From:	
To:	Planning
Subject:	Comments on NYM/2021/0881 - Case Officer Mrs Hilary Saunders - Received from Building Conservation at The Old Vicarage, Bondgate, Helmsley, York, YO62 5BP,
Date:	23 March 2022 14:33:55

Foulsyke House, Foulsyke Farm, Fylingdales NYM/2021/0876/FL & NYM/2021/0881 Re-consult – 23/3/22

Removal of garage, construction of garden room, porch and link extension to store together with alterations to create annexe accommodation.

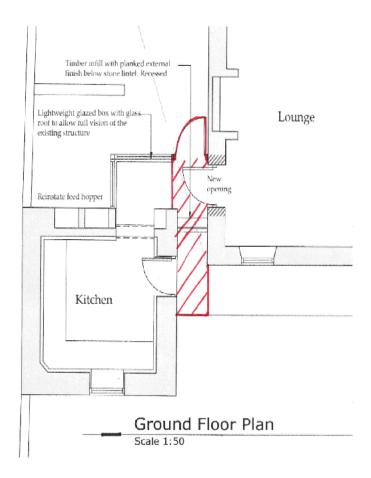
Referring to the proposed glazed link section, to comply with the Dark Night Skies, which are an important part of the National Park, I ask the applicant to consider my proposed location (highlighted in red below) for the link; omitting the need for glazing in favor of materials such as a stone plinth with vertical timber boards (as seen at the garden room). For light I suggest a well-placed timber window and a conservation roof light, combined, this would help mitigate against the increased glazing on the proposed garden room. The roofing system would need to be designed to suit these changes, which I am open to discussion for ideas.

This level of intervention would also preserve all the historic 'feed hoppers'. Looking closely at this outbuilding, what conservation approaches are the applicant considering? Re-pointing with lime for example?
